# ADA Compliance Program

## Clark County Facilities Accessibility Survey Heritage Farms - 78<sup>th</sup> Street

Date of Survey: December 22, 2008  
 Conducted by: Dan Spencer, Laura Pederson, Tim McVicker

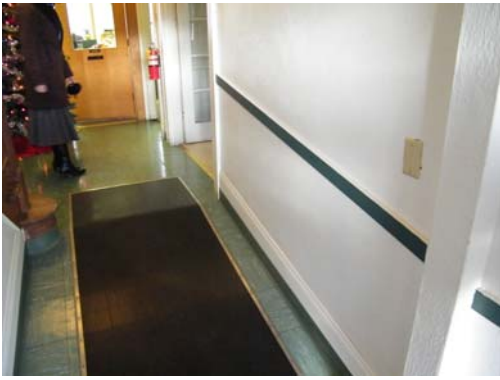
|  | <p>Item # 1</p> <p>Issue: No Accessible Parking</p> <p>Issue:</p> <p>Location: South Parking Lot</p> <p>Code: ANSI 501 General</p> <p>ANSI 501.1 Scope - General site and building elements required to be accessible by the scoping provisions adopted by the administrative authority shall comply with the applicable provisions of Chapter 5.</p> <p>ANSI 502 Parking Spaces</p> <p>ANSI 502.1 General. Accessible car and van parking spaces shall comply with Section 502.</p> <p>Notes: Accessible parking stalls must be constructed pursuant to ANSI Chapter 5</p>  |

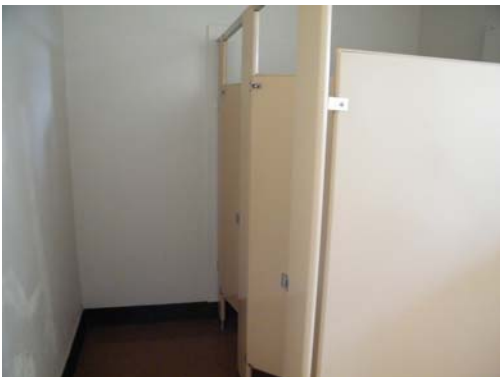
Item # 6  
Issue: Pipe Cover  
Issue: Mirror Height  
Location: Men's Restroom  
Code: ANSI 606.6 Exposed Pipes and Surfaces – Water supply drainpipes under lavatories and sinks shall be insulated or otherwise configured to protect against contact. There shall be no sharp or abrasive surfaces under lavatories and sinks.  
ANSI 1003.11.6 Mirrors - Mirrors above lavatories shall have the bottom edge of the reflecting surface 40 inches (1015 mm) maximum above the floor.

Notes: Complete renovation of restrooms should be explored pursuant to ANSI Chapter 6 and IBC
